SUBMITTAL SUMMARY REPORT

MajorSite-000060-2025

PLAN NAME:	Multi-Family- 8 Units - 351 Marion Oaks Blvd	LOCATION:	351 MARION OAKS BLVD OCALA,
APPLICATION DATE:	11/20/2025	PARCEL:	8004-0433-18
DESCRIPTION:	New 8-unit residential building

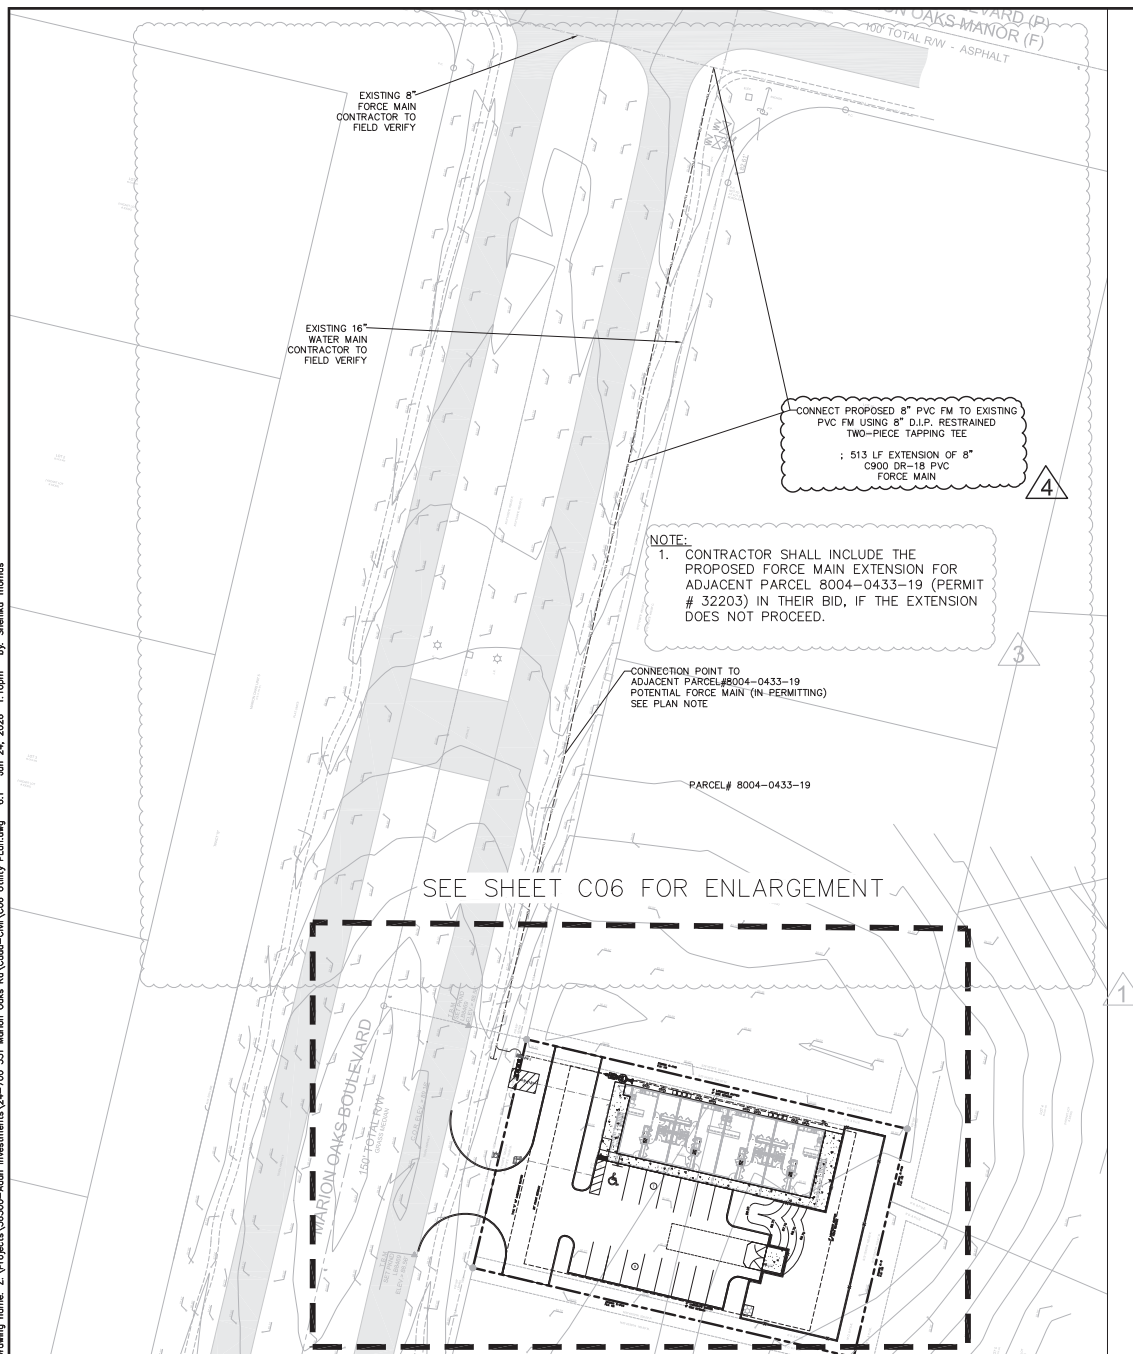
<i>Corrections</i>	6.14.5.A(2) - Proposed mains & connections shown (Resolved) - Corrective Action: C06 - Need plug valve at the FM connection (2) Sheet 6.1 the proposed connection to the FM cannot be a Tee. Must be a wet tap. If this project is forced to extend the sewer from its current location, the correct method of connection will need to be made. - 6.14.5.A(2) - Proposed mains & connections shown:			
<i>Corrections</i>	6.15.4 - Water Main Piping Installation (Resolved) - Corrective Action: C06 – Clearly call out the proposed tap size at the water main connection. The water main located along Marion Oaks Boulevard is a 16-inch main. A 6-inch fire hydrant lead and nine (9) meters cannot be served from a 6-inch tap. Revise to either - Relocate the hydrant to the right-of-way and provide a direct tap to the main, or Install a 6-inch DDC serving a private hydrant. The fire main from the FDC shall be DR-14. Please clarify whether a dedicated fire line connection to the water main is proposed at the single-port Fire Department Connection. - 6.15.4 - Water Main Piping Installation:
